07.08.2015
 scale 1:50
 prints at A2

REVISED
07.08.2015

02

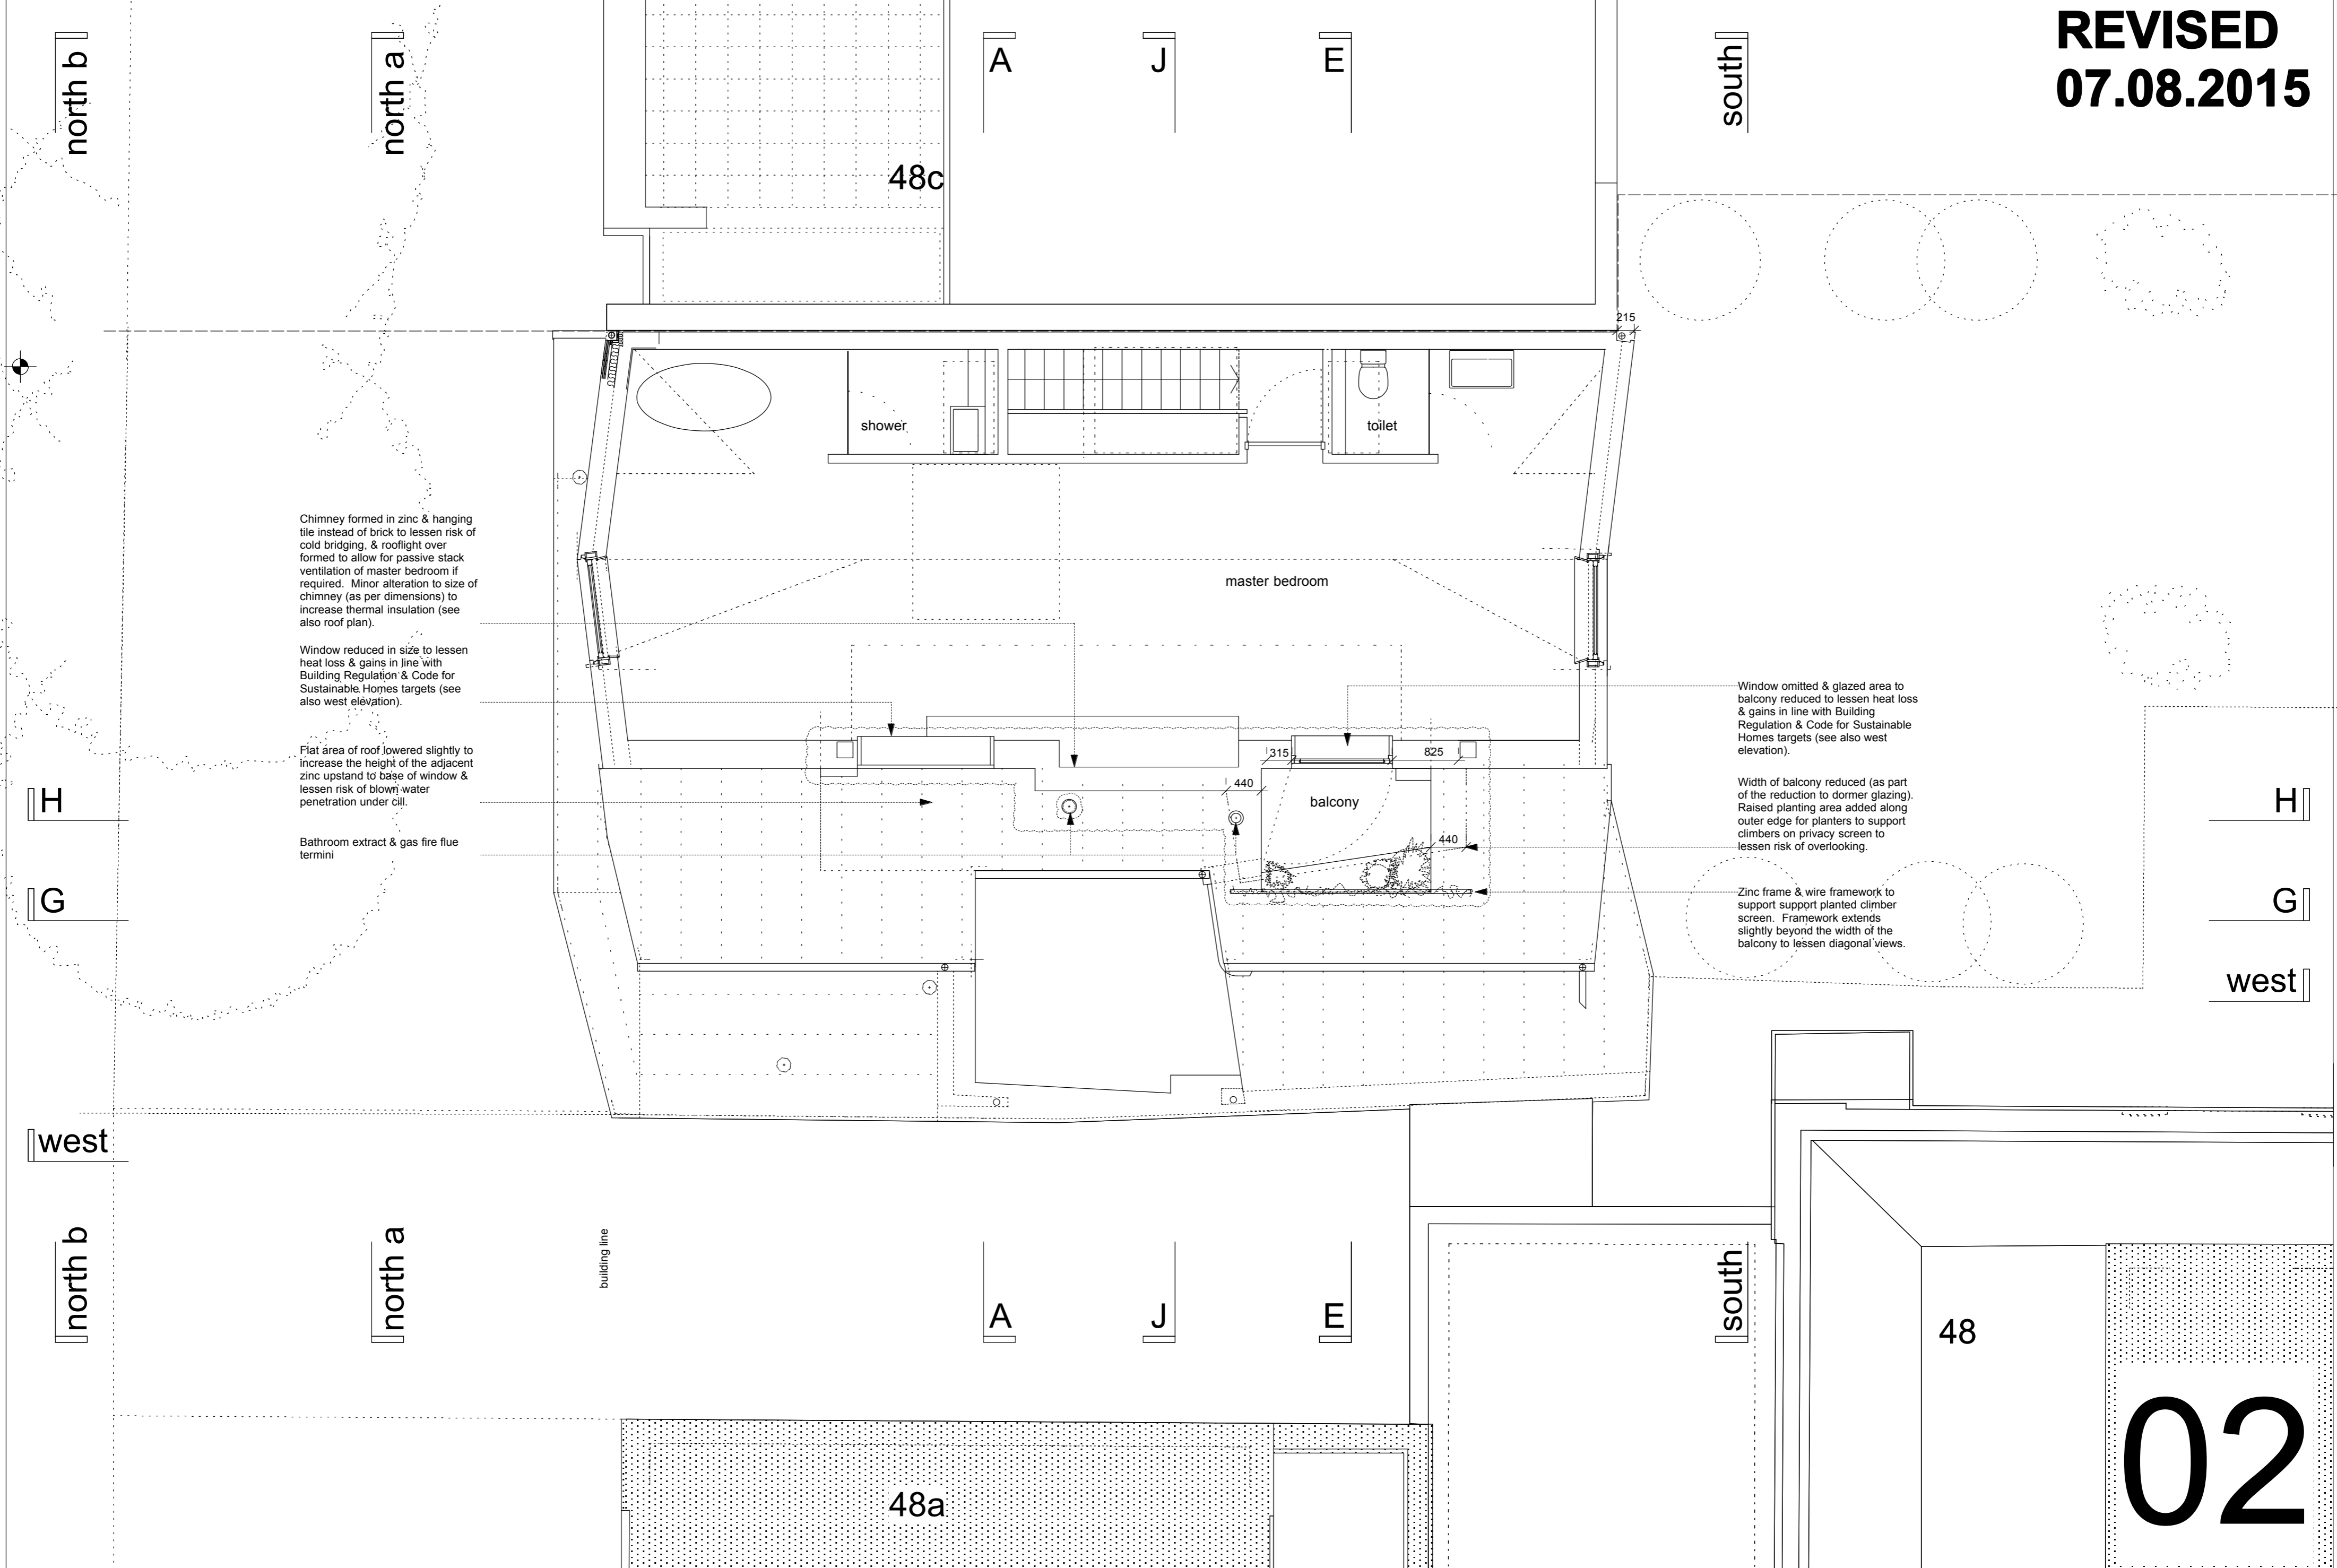
Chimney formed in zinc & hanging tile instead of brick to lessen risk of cold bridging, & rooflight over formed to allow for passive stack ventilation of master bedroom if required. Minor alteration to size of chimney (as per dimensions) to increase thermal insulation (see also roof plan).

Window reduced in size to lessen heat loss & gains in line with Building Regulation & Code for Sustainable Homes targets (see also west elevation).

Flat area of roof lowered slightly to increase the height of the adjacent zinc upstand to base of window & lessen risk of blown water penetration under sill.

Window omitted & glazed area to balcony reduced to lessen heat loss & gains in line with Building Regulation & Code for Sustainable Homes targets (see also west elevation).

Width of balcony reduced (as part of the reduction to dormer glazing). Raised planting area added along outer edge for planters to support climbers on privacy screen to lessen risk of overlooking.

Zinc frame & wire framework to support support planted climber screen. Framework extends slightly beyond the width of the balcony to lessen diagonal views.
